**GLYNN ACADEMY HIGH SCHOOL  
SIDNEY LANIER BUILDING 5018 MODERNIZATION**

**POST BID ADDENDUM NO. 1**

**DATE: May 30, 2018**

**POST BID ADDENDA #1**  
**5/24/2018 1/A2.1**

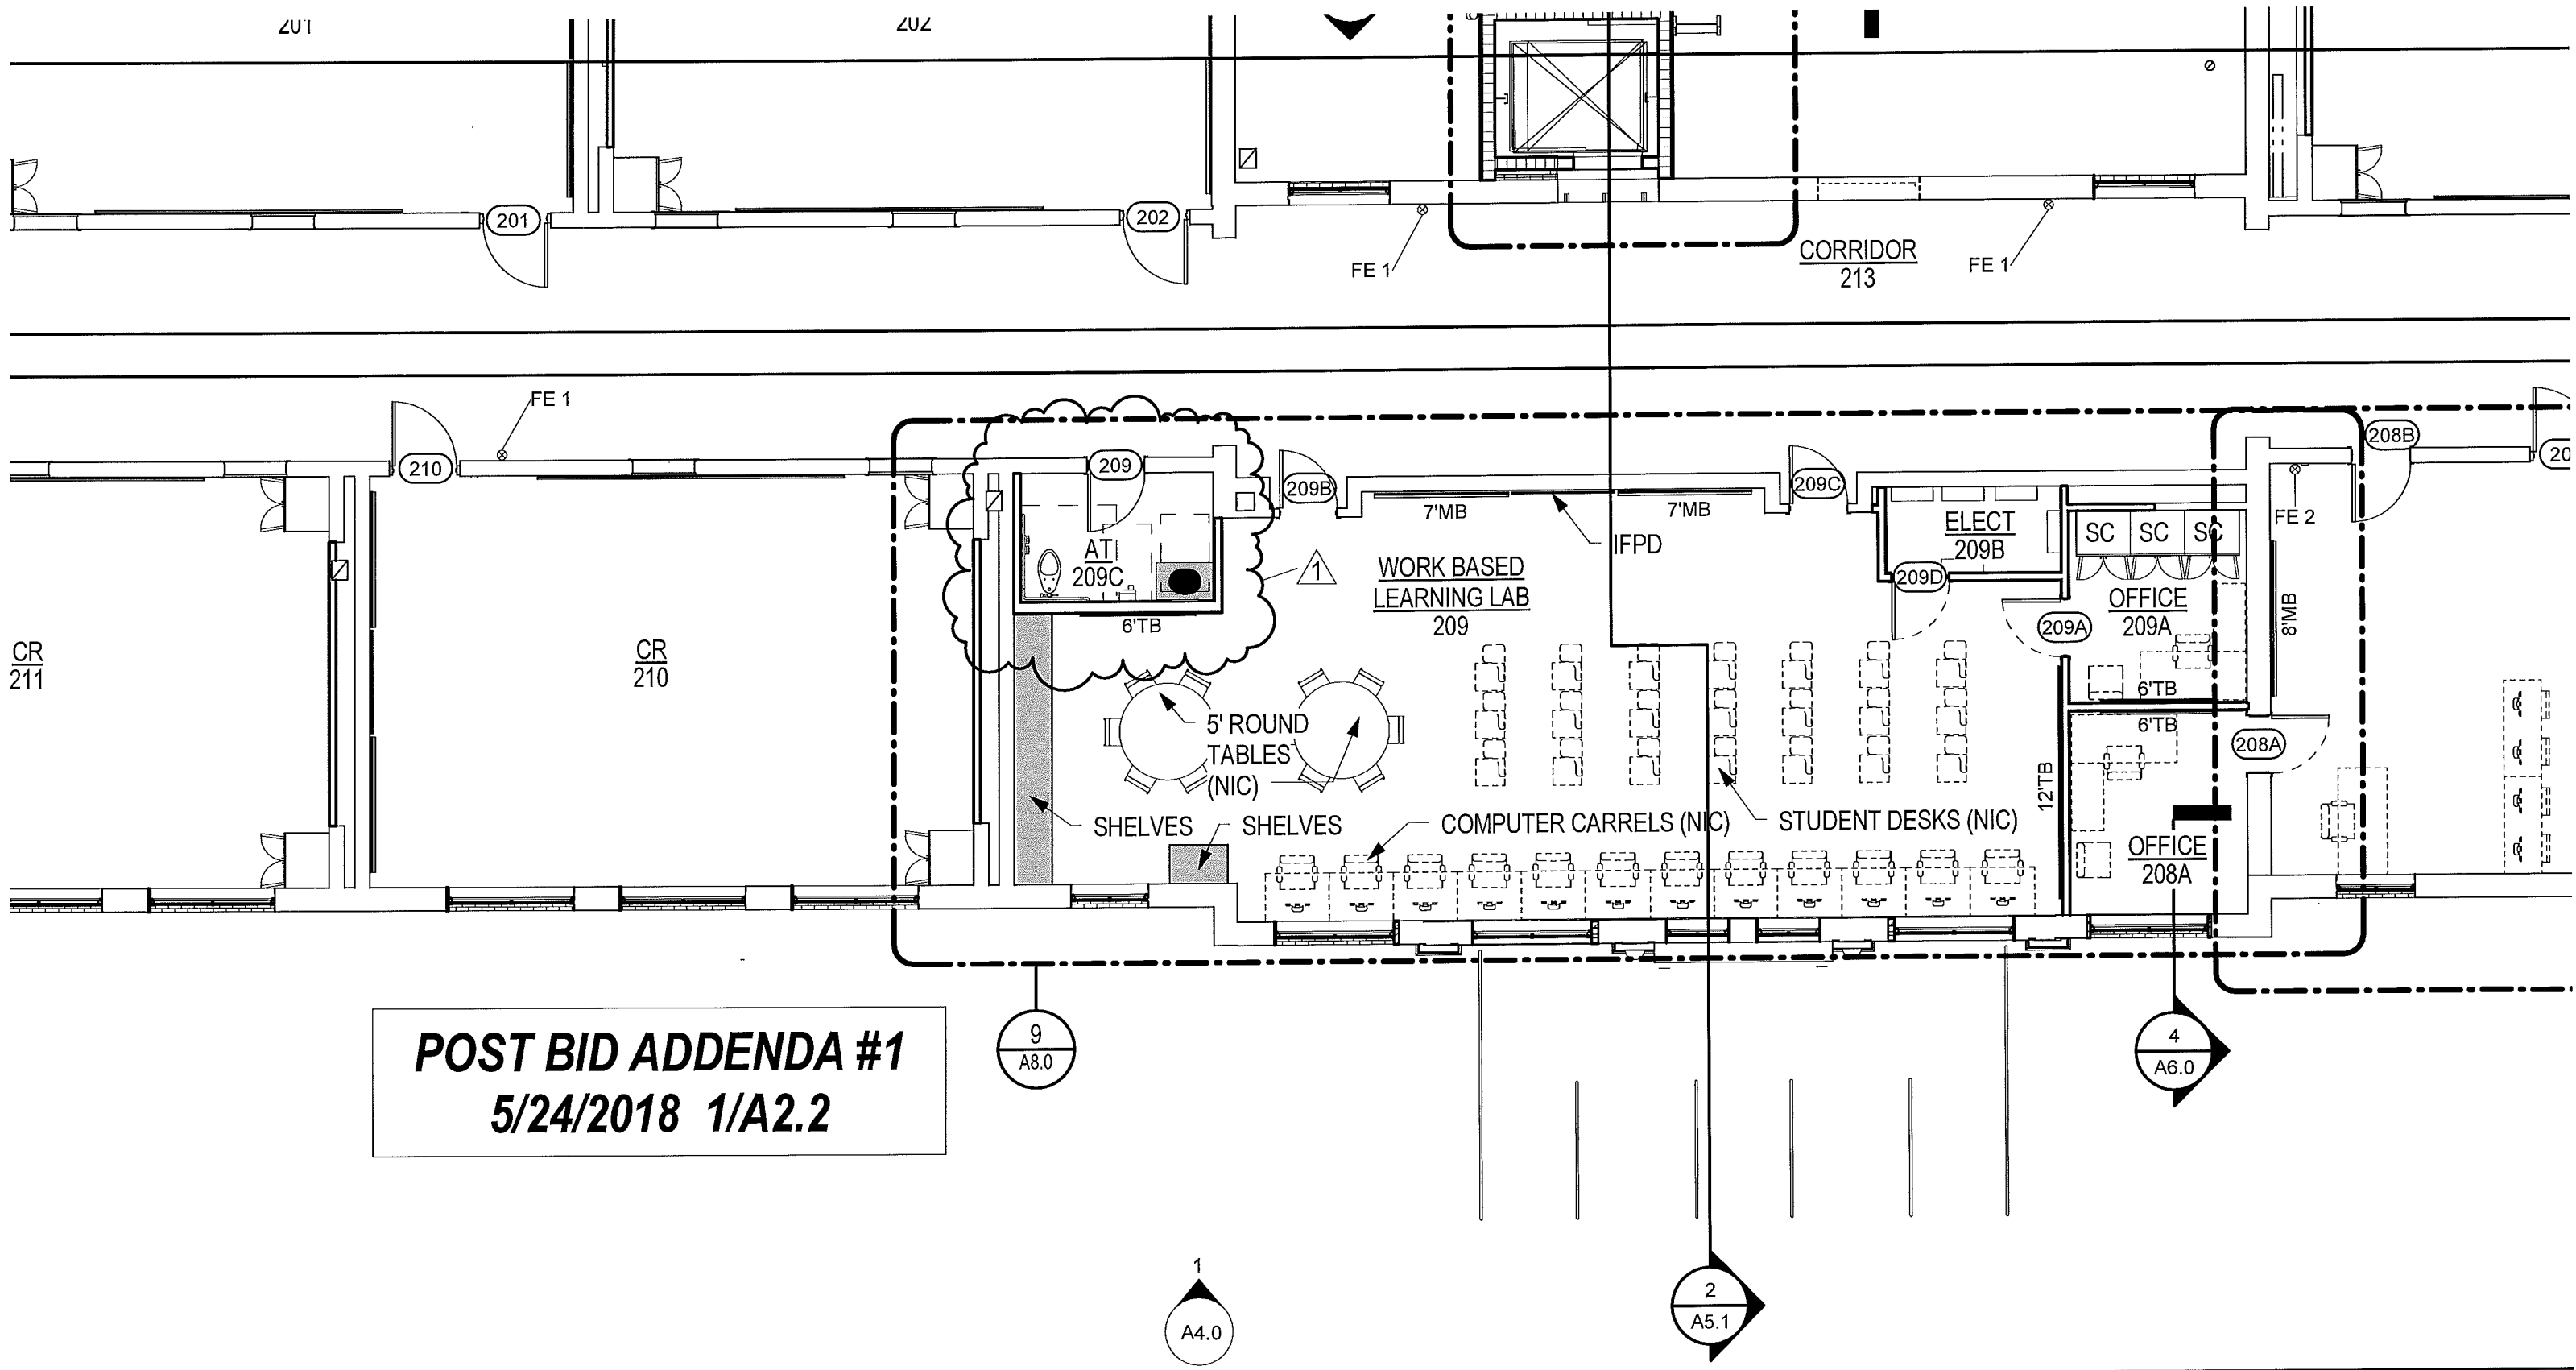
1. Room #115C is revised from Adult Toilet at 115C to Closet 115C. Remove existing plumbing fixtures and repair holes in floor to accept floor finish.
2. Room #118 is revised from Elect. 118 to Office 118.

3. Room #119 is revised from Office 119 to Data 119.
4. Existing Data / Fiber equipment and components in corner of Room #119 is to remain in service – DO NOT DISTURB.

5. Adult Toilet at 119A is revised to Hall 119A. Remove existing plumbing fixtures and repair holes in floor to accept floor finish.
6. Adult Toilet at 119B is revised to Closet 119B. Remove existing plumbing fixtures and repair holes in floor to accept floor finish.

A8.0 SCALE: 1/4" = 1'-0"

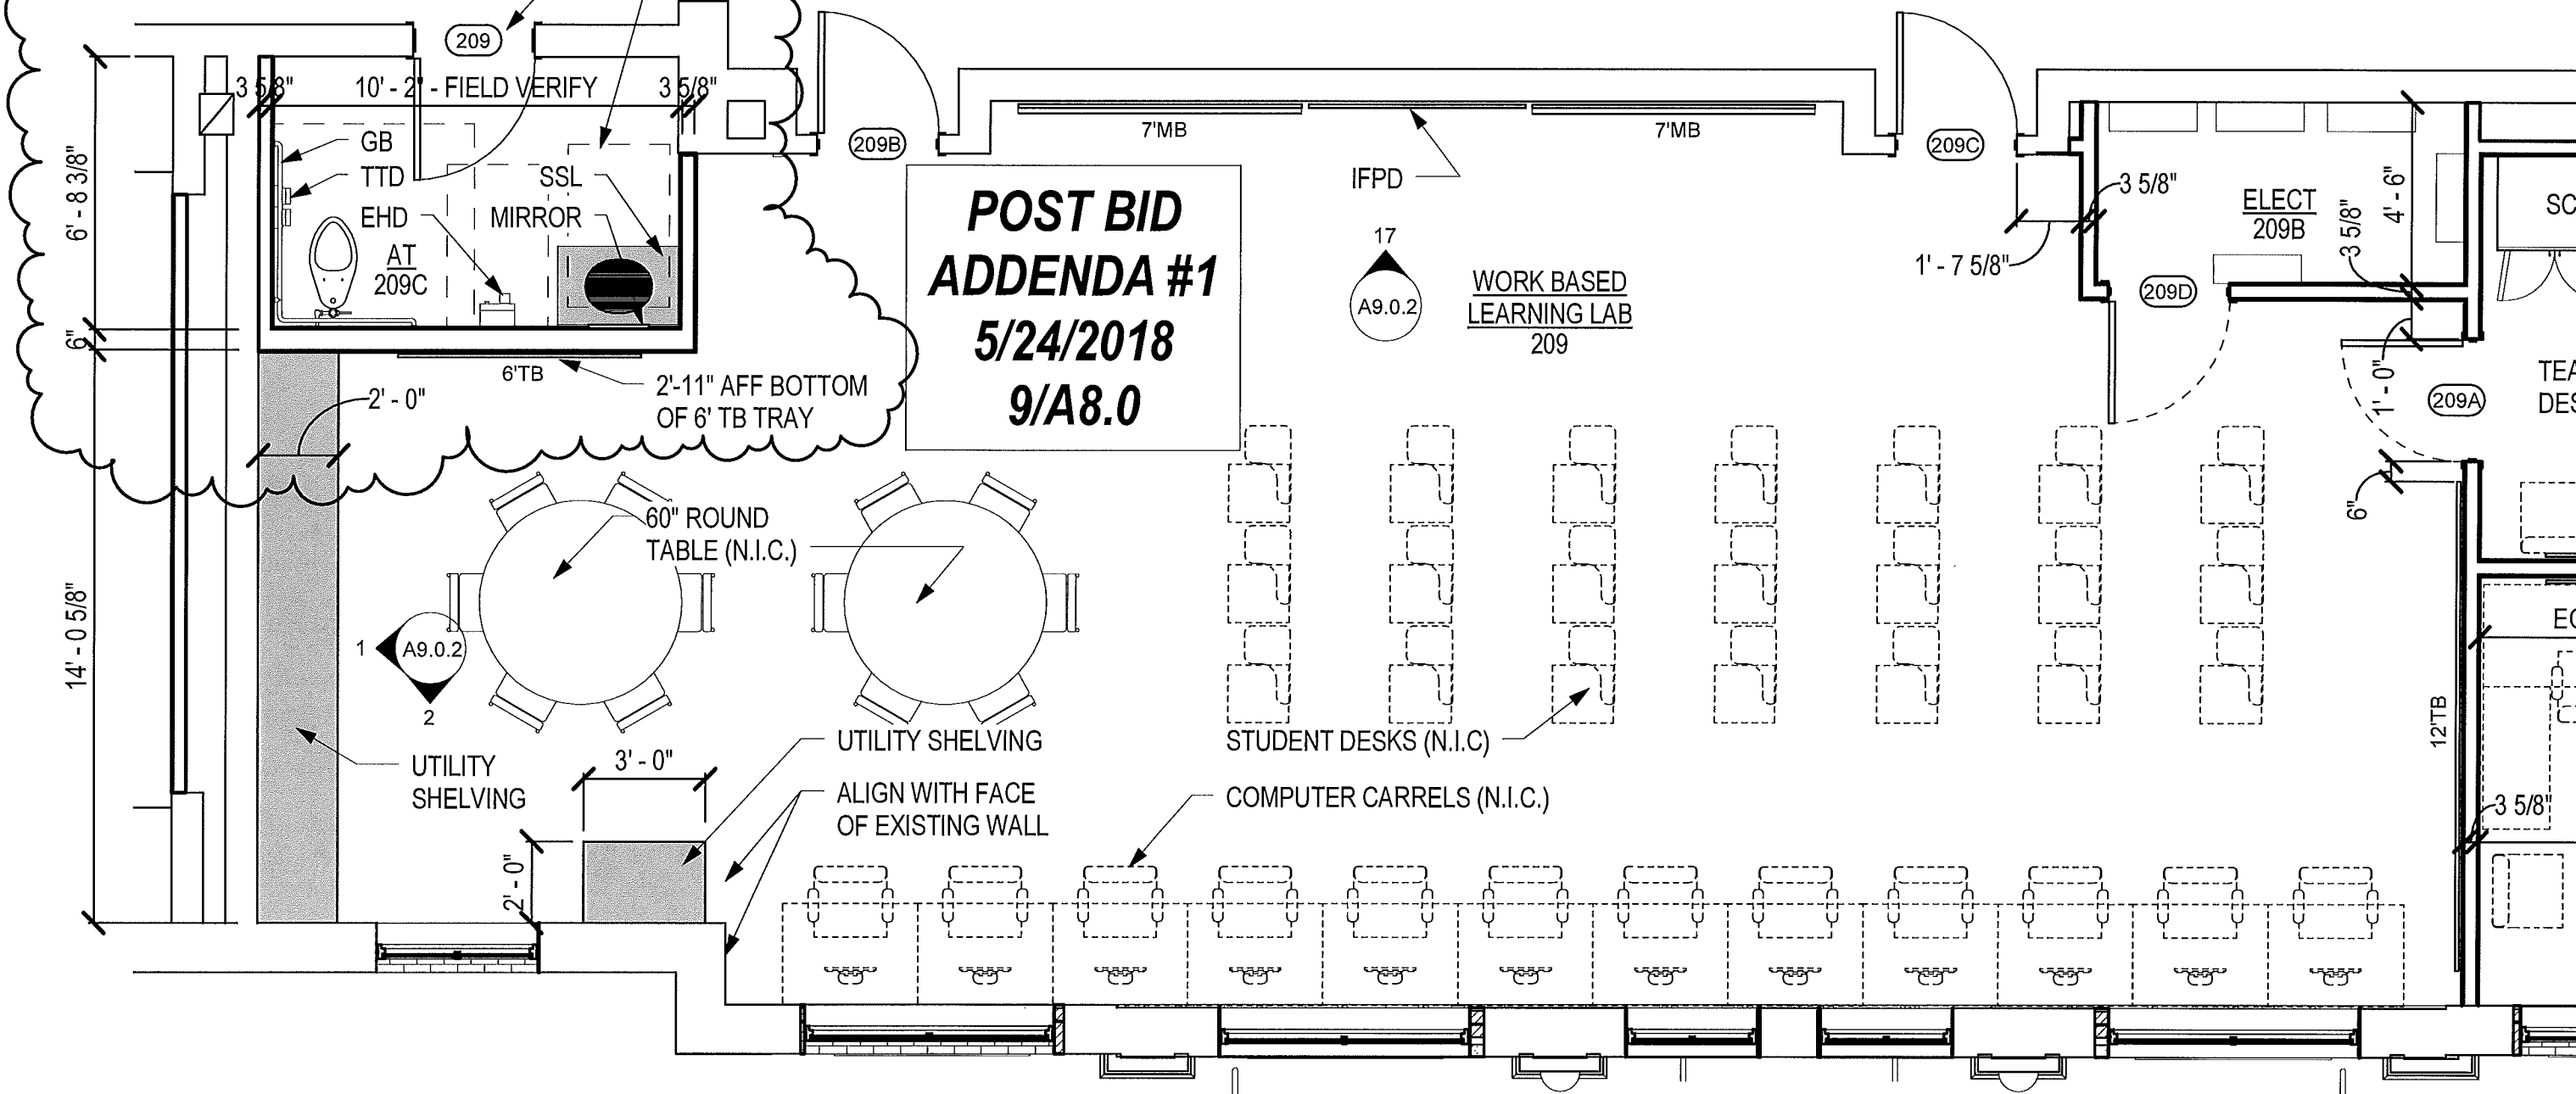
SEE TOILET ROOM DETAILS FOR MOUNTING HEIGHTS AND ADDITIONAL INFORMATION

DOOR #209- EXISTING DOOR TO REMAIN, REPLACE GLAZING WITH OPAQUE

**PARTIAL PLUMBING PLAN - LEVEL 2**

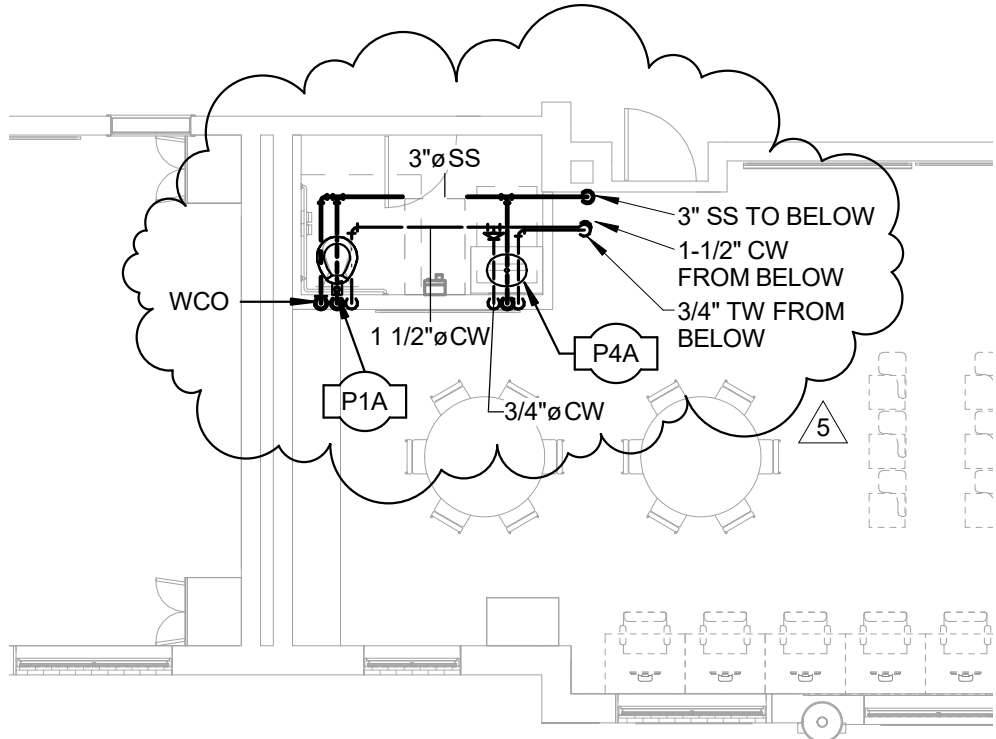
7. Door 119B – Existing frame to remain (Patch and repair / paint as required). Existing door to be removed.
8. Add new Room at 209C (Adult Toilet). New plumbing fixtures, grab bar and electric hand dryer.

**1 PARTIAL MECHANICAL PLAN - LEVEL 2**  
 SCALE: 1/8" = 1'-0"

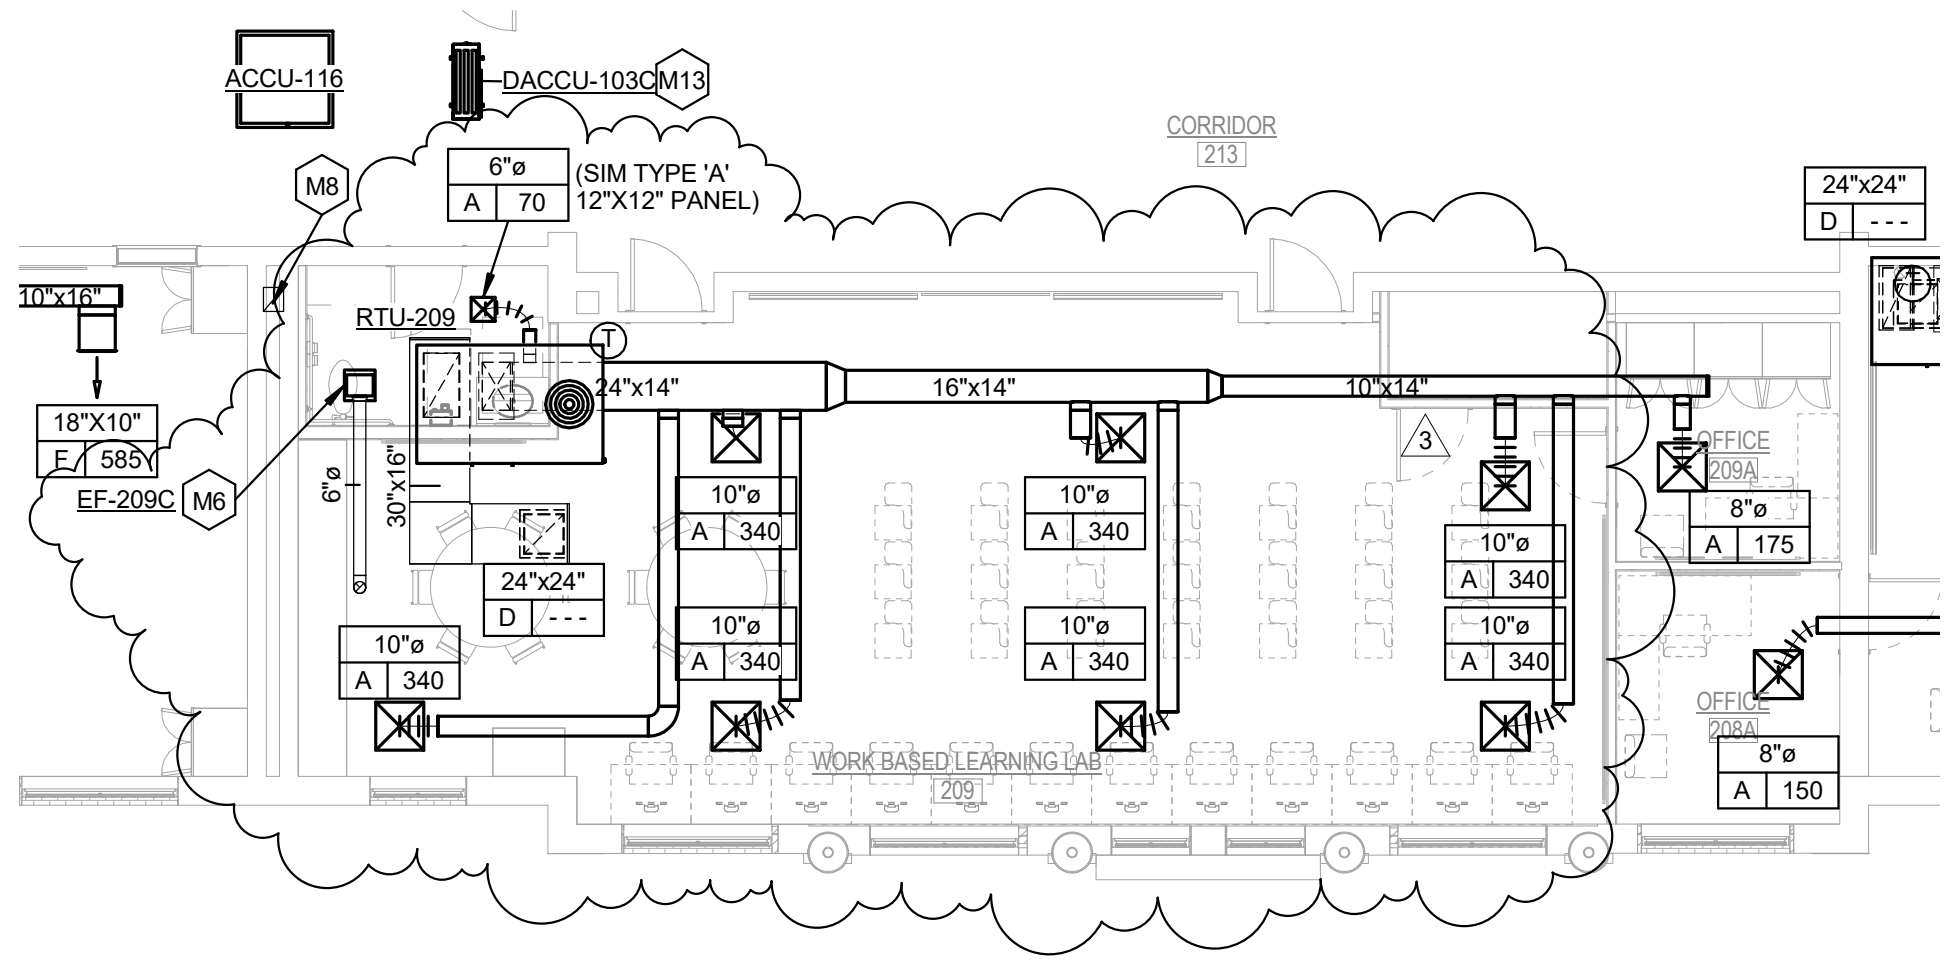
11. It is the intent to keep the existing chair rail in the corridors. Where lockers are removed, provide new chair rail to match existing.
